# Recall Bulletin

## PRODUCT SAFETY RECALL

**SUBJECT:** Electric Power Steering Assist

**Serviced under Safety Recall 10023 Prior to May 31, 2010**

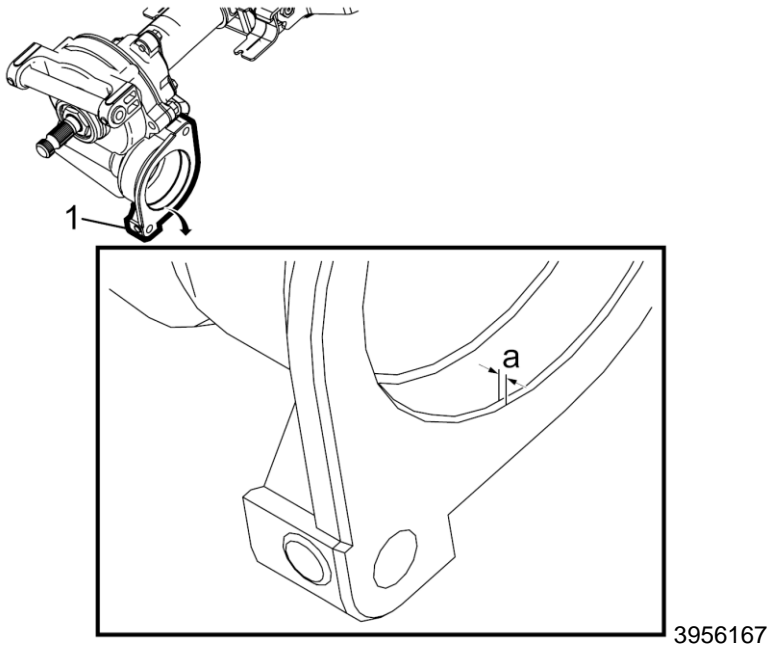
**Caution:** First design steering motor with a small chamfer does not require a seal. If a seal is installed on a first design steering motor, potential damage to the steering motor may occur resulting in loss of assist steering. Seal is only required for the second design steering motor with the larger chamfer. Before installing the power steering assist motor, inspect the power steering assist motor housing (1) to verify the steering column design.

- *First Design:* If the chamfer (a) is **1 mm (0.04 in)** and **30 degrees** then the steering column is the first design and a power steering assist motor O-ring seal is NOT needed.
- *Second Design:* If the chamfer (a) is **2.7 mm (0.11 in)** and **45 degrees** then the steering column is the second design and a NEW power steering assist motor O-ring seal IS needed.
